ADDENDUM NO. 2

**LEWIS STREET AND 2ND AVENUE PARKING LOT IMPROVEMENTS
CITY OF SHAKOPEE
STORM 24-001, PA-24-03
PA-24-05**

ISSUED: Tuesday, April 16, 2024

GENERAL NOTES

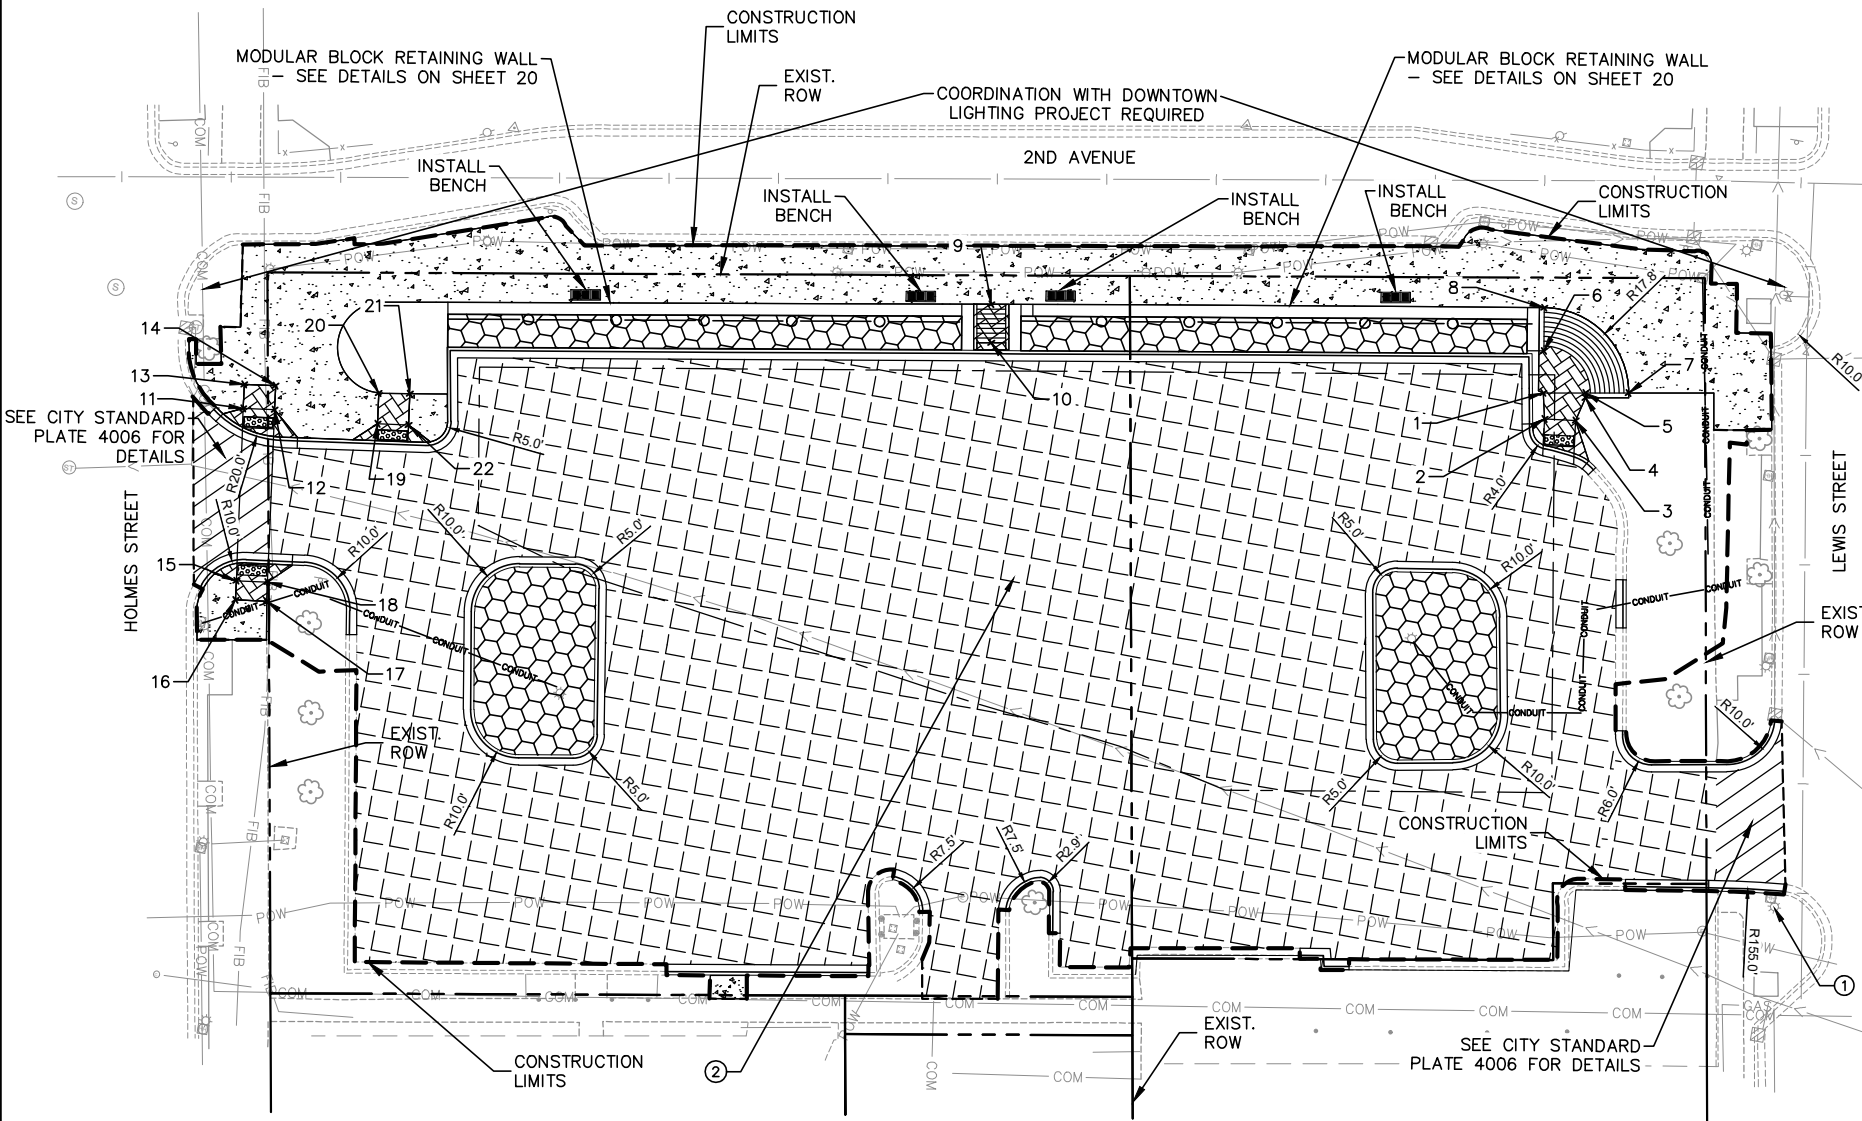
SHEET 3

Remove Note 8.

RETAINING WALL DETAILS
AND NOTES

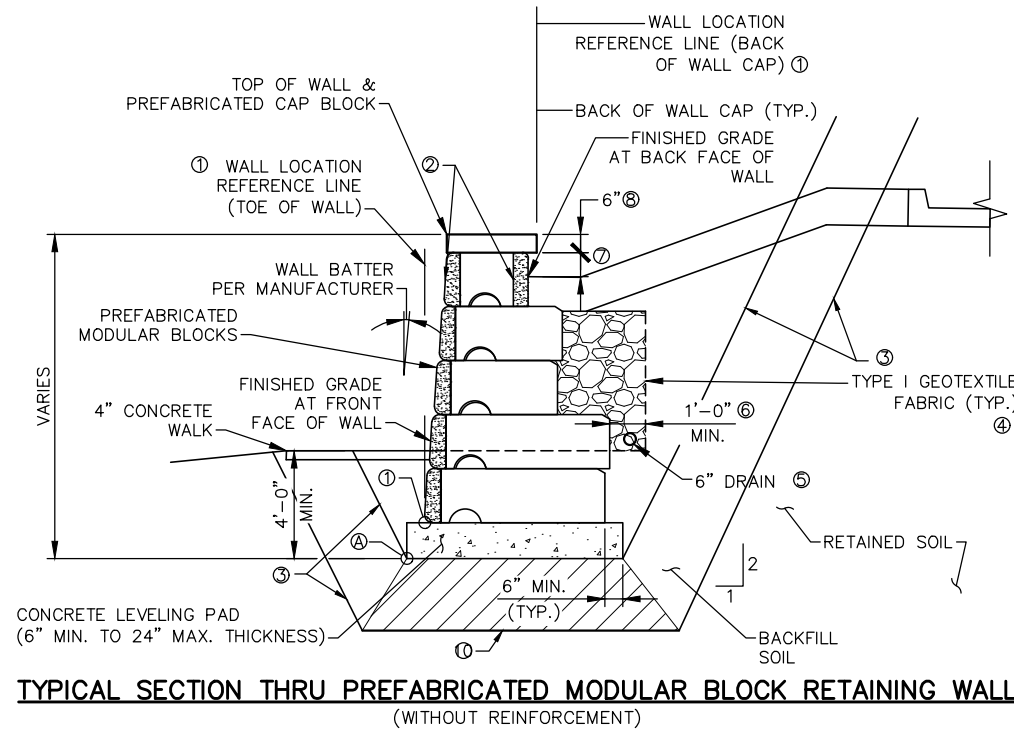
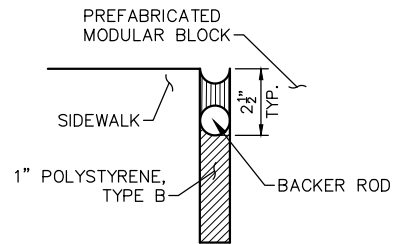
SHEET 20

Append the following sentence to the end of Note 10:

ALL WORK AND MATERIALS ASSOCIATED WITH THE LEVELING PAD AND FILL ARE INCLUDED IN THE BID ITEM “PREFABRICATED MODULAR BLOCK WALL”.

CITY OF SHAKOPEE
LEWIS STREET AND 2ND AVENUE
PARKING LOT IMPROVMENTS
STORMWATER DETAILS

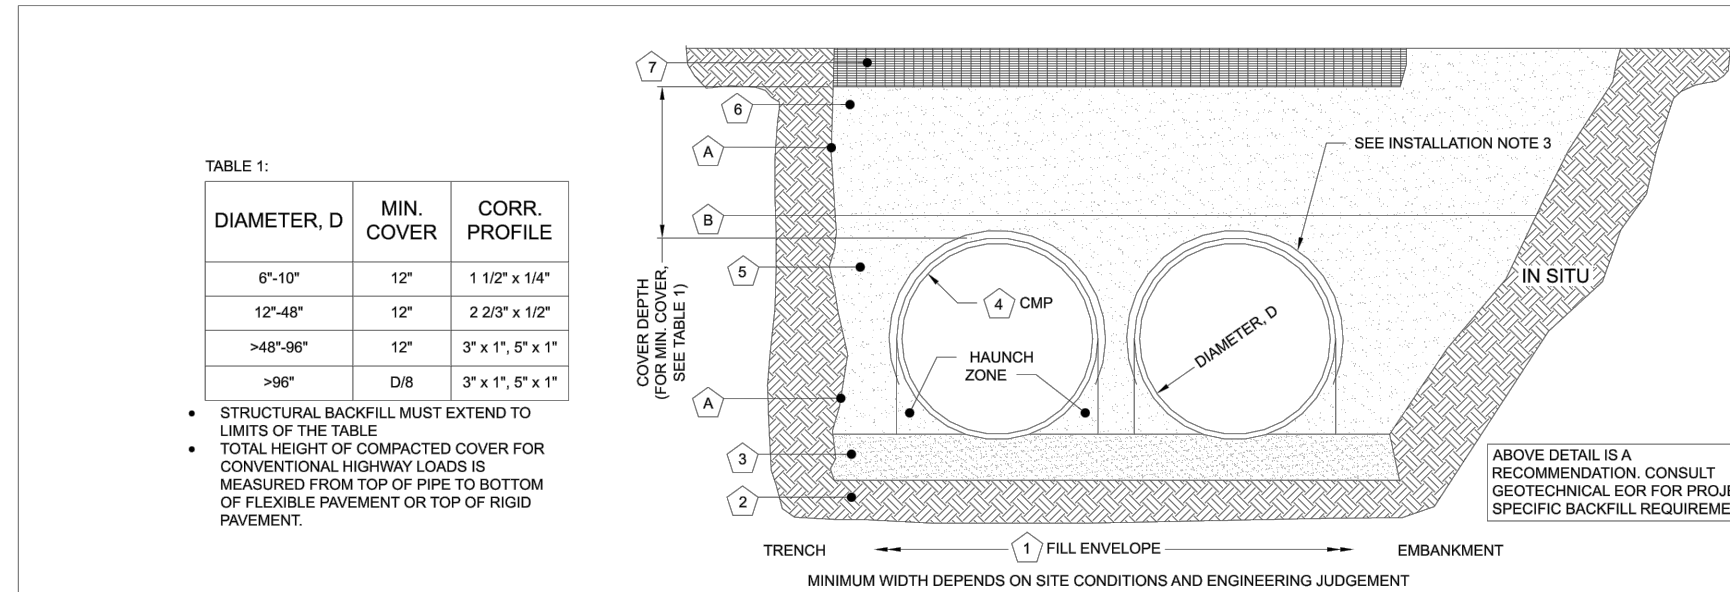
SHEET 28

Append the following to column 2 of note 5 in Table 2:

INCIDENTAL TO UNDERGROUND INFILTRATION SYSTEM

SHAKOPEE
 CITY OF SHAKOPEE
 LEWIS STREET AND 2ND AVENUE
 PARKING LOT IMPROVEMENTS
 STORMWATER DETAILS

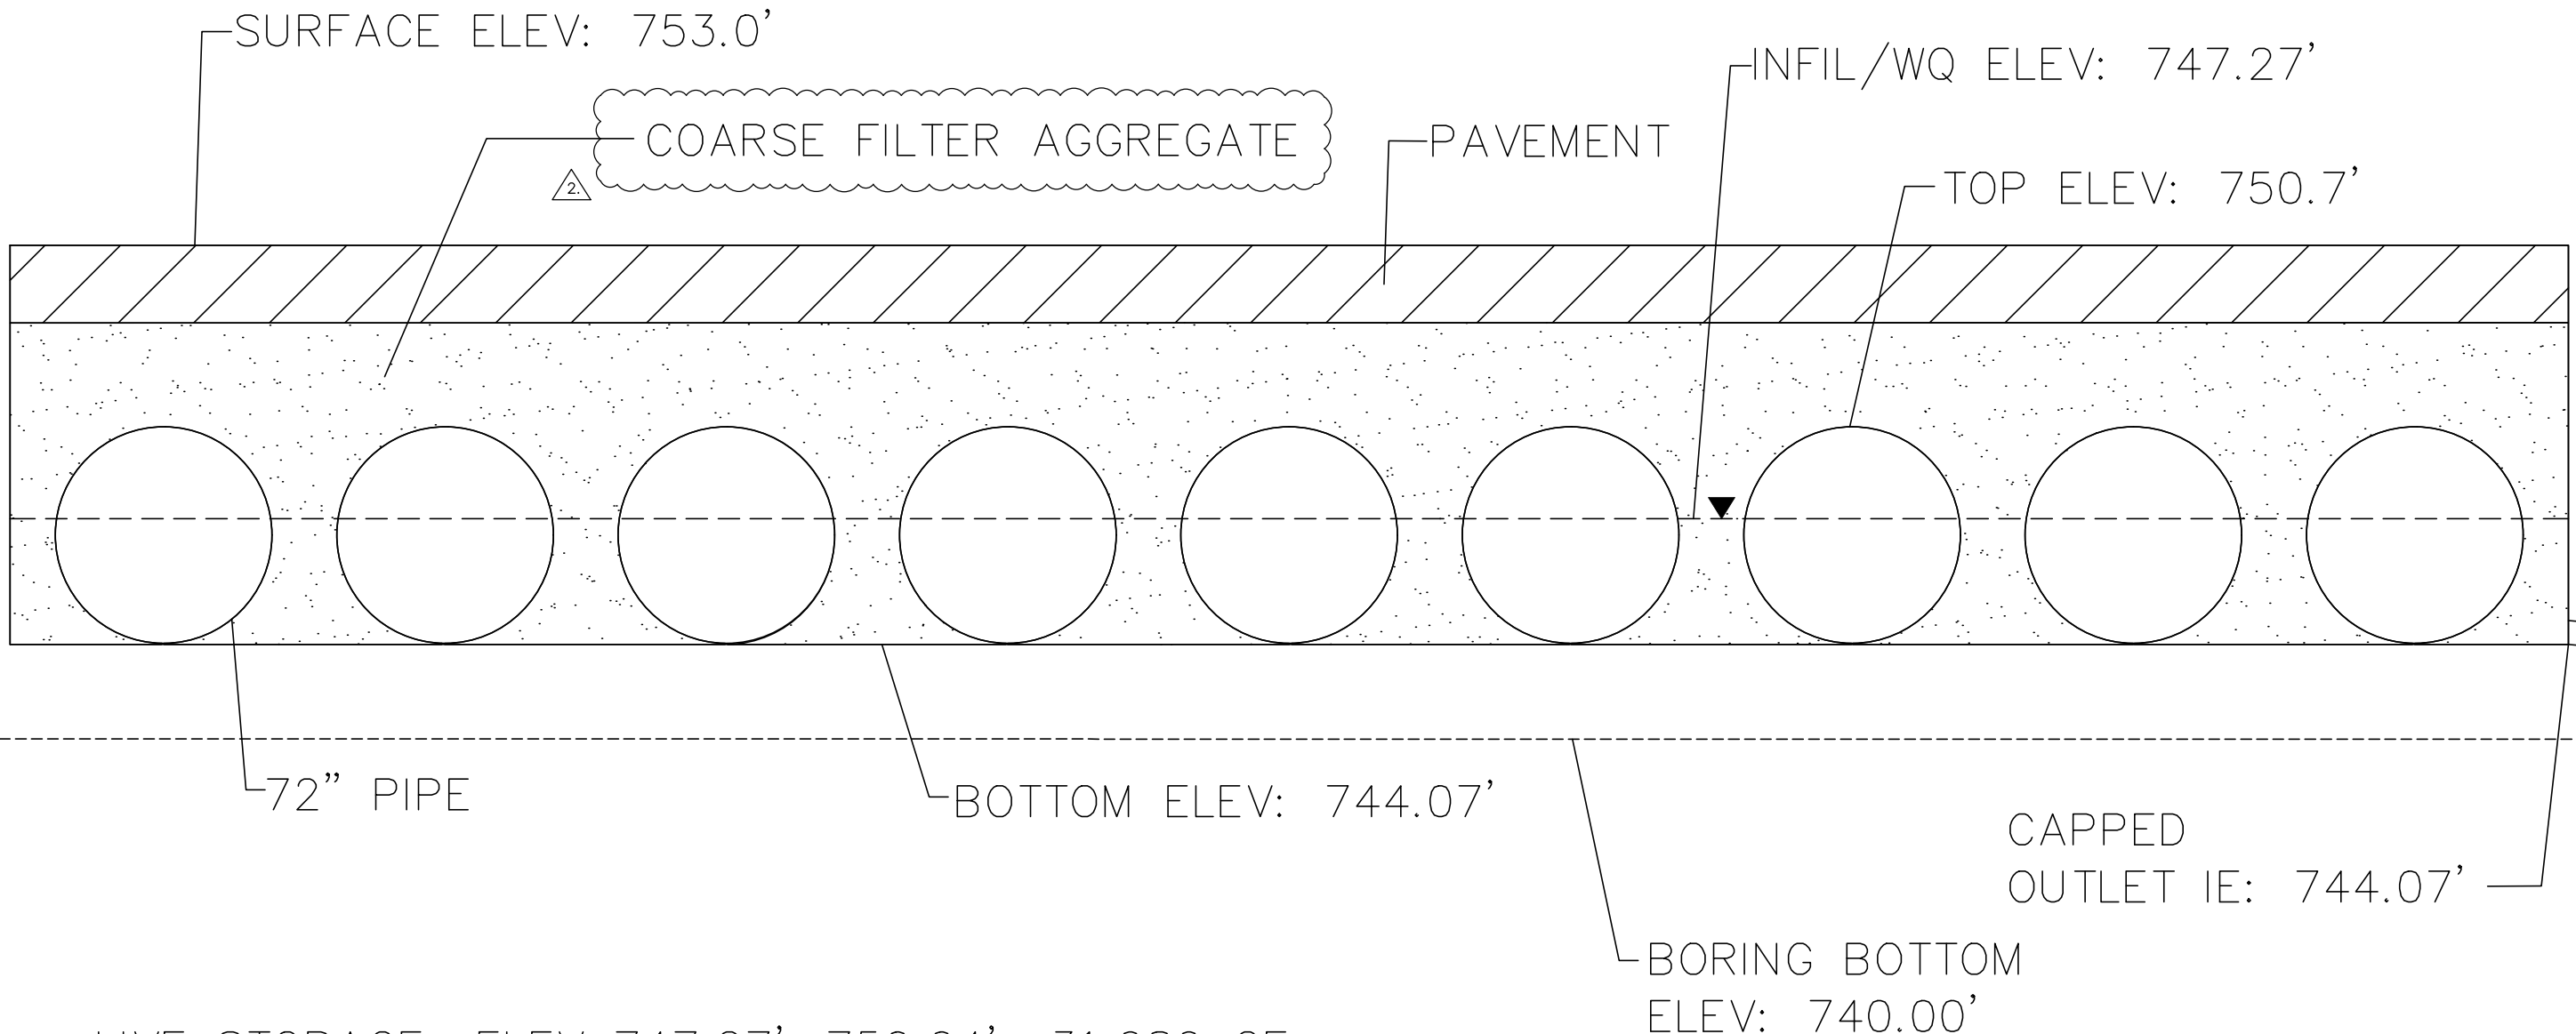
SHEET 31

Remove detail label for Backfill section and replace with the following:

COARSE FILTER AGGREGATE label.
